UNITED STATES PATENT AND TRADEMARK OFFICE

APPLICATION NO.	FILING DATE	FIRST NAMED INVENTOR	ATTORNEY DOCKET NO.	CONFIRMATION NO.
10/684,684	10/15/2003	Kohei Yamanaka	Q76899	3402

Office Action Summary

DETAILED ACTION

Smith et al., 3,688,521.

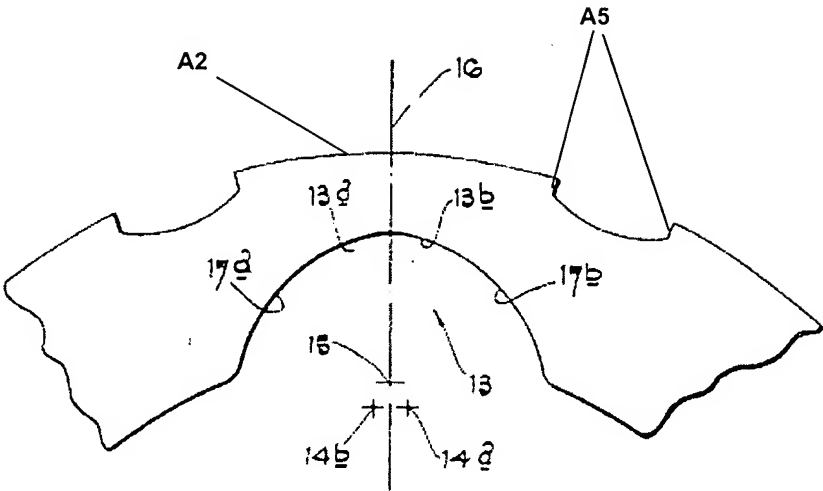
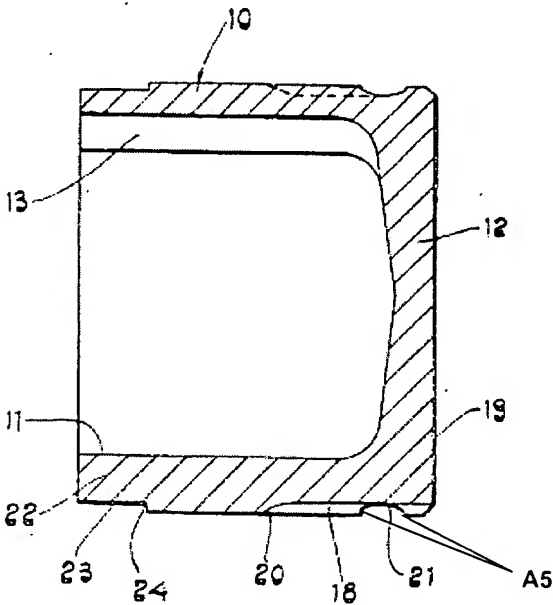
Regarding claim 1, Smith et al. discloses, in Figure 1-4, a structure comprising a shaft member **26** and a cylindrical member **25**. The shaft member **26** is formed out of a first material. The shaft member **26** has an outer periphery **A2** formed with an axial groove **18** and a circumferential groove **21**. The axial groove **18** and the circumferential groove **21** have a cross-section having opposed faces **A5** substantially parallel to each other. The cylindrical member **25** is fitted to the outer periphery **A2** of the shaft member **26**. A caulked portion **18** is provided to the cylindrical member **25** at an intersection of the axial groove **18** and the circumferential groove **21** (col. 3, lines 19-24; Figure 4 shows an intersection). The caulked portion **18** has a deformed inner surface **A8** in press contact with the faces **A5** of the circumferential groove **21** and the caulked portion has a deformed inner surface in press contact with the opposed faces of the axial groove (col. 3, lines 19-24). However, Smith et al. do not disclose the cylindrical member **25** being formed out of a second material greater in linear expansion coefficient than the first material.

Regarding claim 6, the axial groove **18** comprises a plurality of groove portions in a circumferential direction.

Regarding claim 7, the groove portions are three in number.

Regarding claim 9, the cylindrical member **25** is loosely fitted to the shaft member **26** except the caulked portion **18**. Applicants should note that anywhere there is not a caulked portion there is no connection and thus the cylindrical member is loosely fitted to the shaft member as well.

Regarding claim 8, Smith et al., as discussed, fails to disclose the axial groove **18** and the circumferential groove **21** being rectangular. Applicants are reminded that a change in the shape of a prior art device is a design consideration within the skill of the art. In re Dailey, 357 F.2d 669, 149 USPQ 47 (CCPA 1966). Therefore, it would have been obvious to one of ordinary skill in the art at the time the invention was made to design the groove of a rectangular cross section as taught by Fujioka et al., Fig. 8.

Regarding claim 10, Smith et al., as modified, fail to disclose the axial groove **18** having an opening edge formed at an acute angle. Edgemon, Jr. teaches, in Figure 2, an axial groove **18** having an opening edge formed at an acute angle. Edgemon, Jr. does not state why the opening edge is formed at an acute angle. Applicant is reminded that side faces of a rectangular axial groove formed on a cylindrical surface inherently form an opening edge at an acute angle as part of a design consideration. Therefore, as taught by Edgemon, Jr., it would have been obvious to one of ordinary

Regarding claim 2, Smith et al., as modified, fail to disclose the axial groove **18** and the circumferential groove **21** being different in depth from each other. Krude et al. teach, in Figure 5, an axial groove **11** and the circumferential groove **12** being different in depth from each other to receive portions of the material of the cylindrical member which will consist of a diameter reduction of the cylindrical member and the material volume displaced by tooth portions (col. 6, lines 11-18). Therefore, as taught by Krude et al., it would have been obvious to one of ordinary skill in the art at the time the invention was made to make the axial groove **18** and the circumferential groove **21** different in depth from each other to receive portions of the material of the cylindrical member consisting of a diameter reduction of the cylindrical member and material volume displaced by tooth portions between the axial grooves.

Regarding claim 5, given the modification, the caulked portion comprises a first caulked part corresponding to the circumferential groove **21** and a second caulked part corresponding to the axial groove **18**. The second caulked part would be arranged substantially in a middle of the first caulked part.

Regarding claim 3, Smith et al., as modified above, fail to disclose the axial groove **18** greater in depth than the circumferential groove **21**. Applicants are reminded that a mere reversal of the essential working parts of a device involves only routine skill in the art; therefore, it would have been obvious to one having ordinary skill in the art at the time the invention was made to make the groove with a greater depth than that of the circumferential groove or vice versa. *In re Einstein*, 8 USPQ 167. Further, See Jackman as Figures 3-4 teach an axial groove greater in depth than the circumferential groove.
